KCOS Master Plan

ACOS coordination with BWFR

Re: LE24-002 - Kiowa Creek Open Space Regional Park, 1001 N County Road 137

BWFR Access Routes

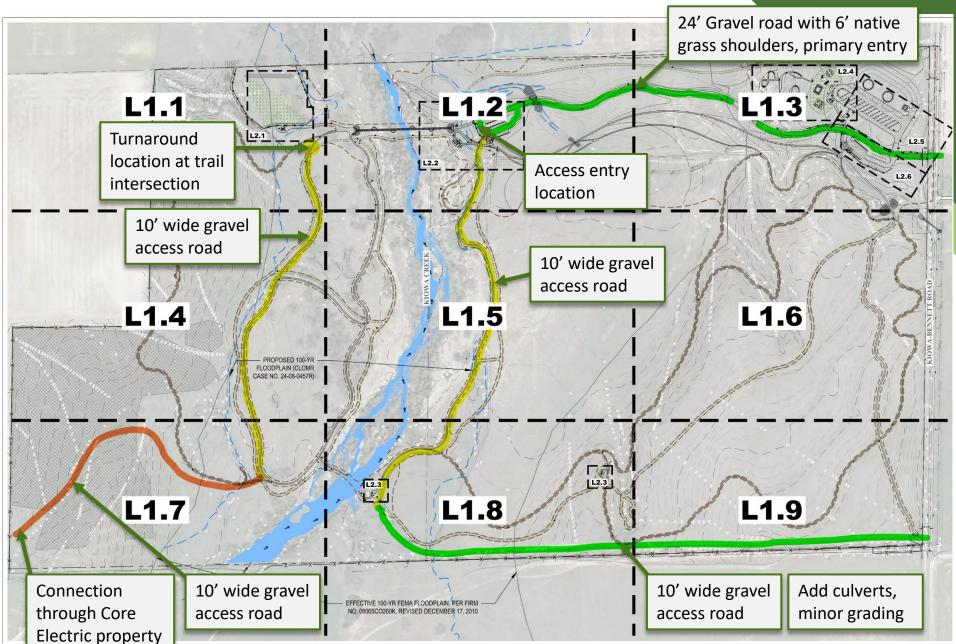
- BWFR has identified functionality and safety concerns regarding the proposed access widths
 throughout the site. The current design, which includes a 22-foot-wide main access and 6to 10-foot-wide mowed and gravel trails, does not adequately support simultaneous ingress
 and egress during emergency situations. We are concerned that these width configurations
 could significantly impede both evacuation of park visitors and entry of emergency vehicles
 during a wildfire, medical emergency, or other incident.

- To support safe and effective emergency response operations, the main access route should be increased to a minimum of 26 feet in width to allow for emergency vehicle staging, two-way traffic flow, and improve operations during incidents. Additionally, a continuous, drivable access loop with a minimum width of 12 feet should be provided throughout the internal trail network, for use by smaller emergency apparatus to access more remote incident locations. This access is essential not only for wildfire mitigation but also for emergency medical response, particularly considering elevated risk throughout the area due to planned recreational activities such as hiking, physical fitness activities, and equestrian use. BWFR requests the opportunity to collaborate with Arapahoe County and the developer to review the site's drivability and ensure the access design adequately supports a broad-range of emergency incident scenarios.

- Due to the elevated wildfire risk associated with the proposed uses and surrounding landscape of the Kiowa Creek Open Space Regional Park, BWFR is requiring the applicant to conduct a wildfire interface assessment of the site to identify wildfire ignition sources and
